# RFB-2024-57 GLENVILLE, NISKAYUNA, SCOTIA LIBRARIES INTERIOR RENOVATIONS

#### **ADDENDUM #2**

Issued Date: 09/19/2024

NISKAYUNA - FINISH PLAN AND SCHEDULE

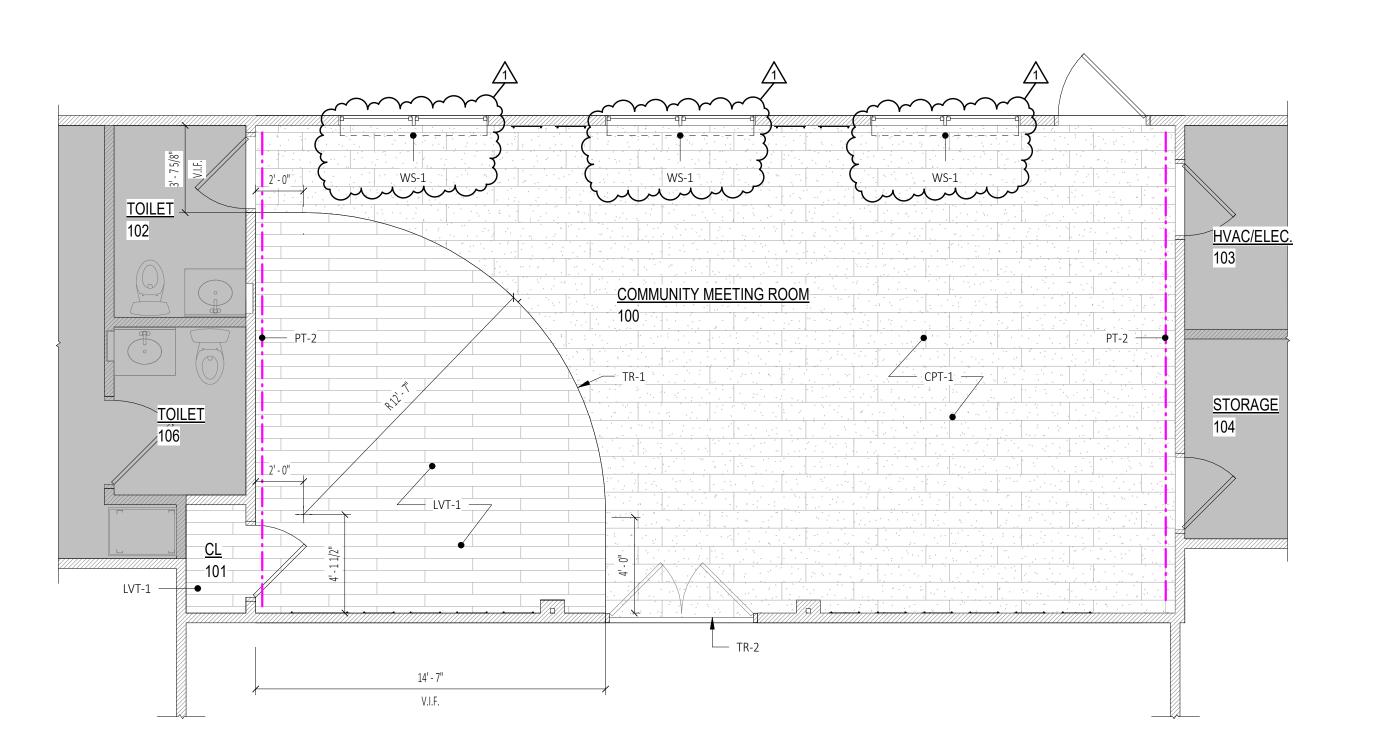
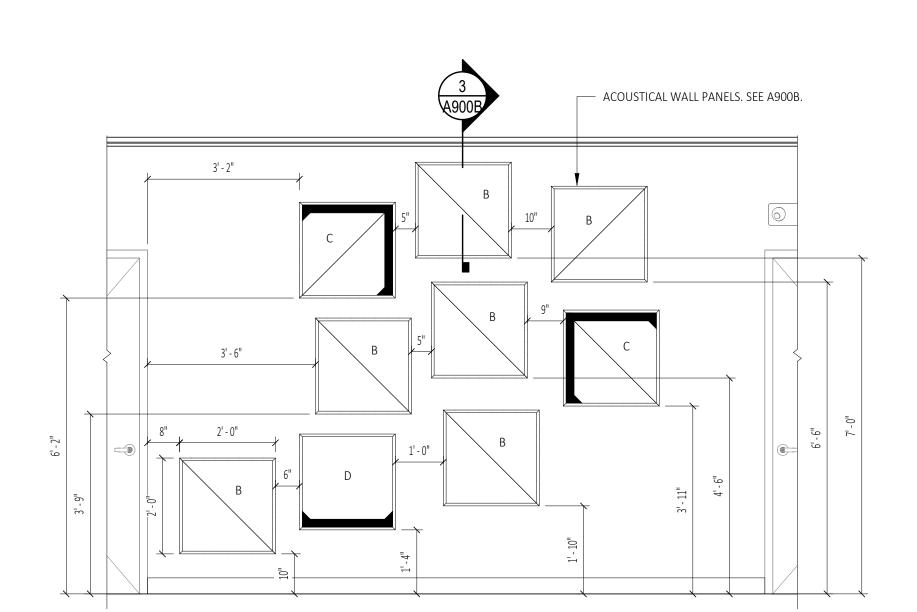
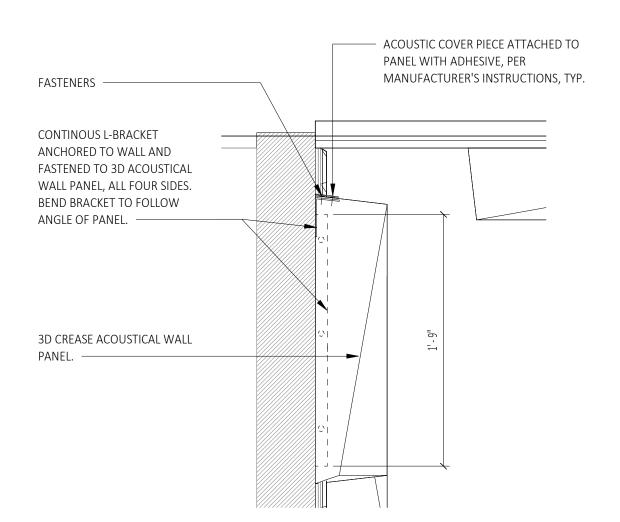
- 1. Drawing A900B
  - a. Add note for WS-1 Window Shades location and requirement for 3% Openness.

UXURY VINYL	TILE				
LVT-1	LUXURY VINYL TILE	SHAW CONTRACT	ORIGIN 4338V   INITIATE	5.66" X 47"	COMMUNITY ROOM. SEE FINISH PLAN.
PAINT					
PT-1	PAINT	SHERWIN WILLIAMS	ALABASTER	-	COMMUNITY ROOM. SEE ELEVATIONS.
PT-2	PAINT	SHERWIN WILLIAMS	FADED FLAXFLOWER	-	COMMUNITY ROOM. SEE ELEVATIONS.
RUBBER BASE					
RB-1	RUBBER BASE	TARKETT	DURACOVE   COLOR TO BE SELECTED BY ARCHITECT	4"	SEE INTERIOR ELEVATIONS.
RANSITION S	TRIP				
TR-1	TRANSITION STRIP	JOHNSONITE	SLIM LINE TRANSITIONS   COLOR TO BE SELECTED BY ARCHITECT	-	COMMUNITY ROOM. SEE FINISH PLAN.
TR-2	TRANSITION STRIP	JOHNSONITE	WHEELED TRAFFIC TRANSITIONS   COLOR TO BE SELECTED BY ARCHITECT	-	COMMUNITY ROOM. SEE FINISH PLAN.
VINDOW SHA	DES	$\sim$	$\lambda$	$ \\ \\ \\ \\ \\ \\ \\ \\ \\ \\ \\ \\ \\ \\ \\ \\ \\ \\ \\$	$ \\ \\ \\ \\ \\ \\ \\ \\ \\ \\ \\ \\ \\ \\ \\ \\ \\ \\ \\$
WS-1	WINDOW SHADES	DRAPER	MANUAL CLUTCH-OPERATED FLEXSHADE   M SCREEN WITH 3% OPENNESS   COLOR TO BE SELECTED BY ARCHITECT	VARIES. COORDINATE WITH WINDOW S	SIZE. COMMUNITY ROOM. SEE ELEVATIONS.
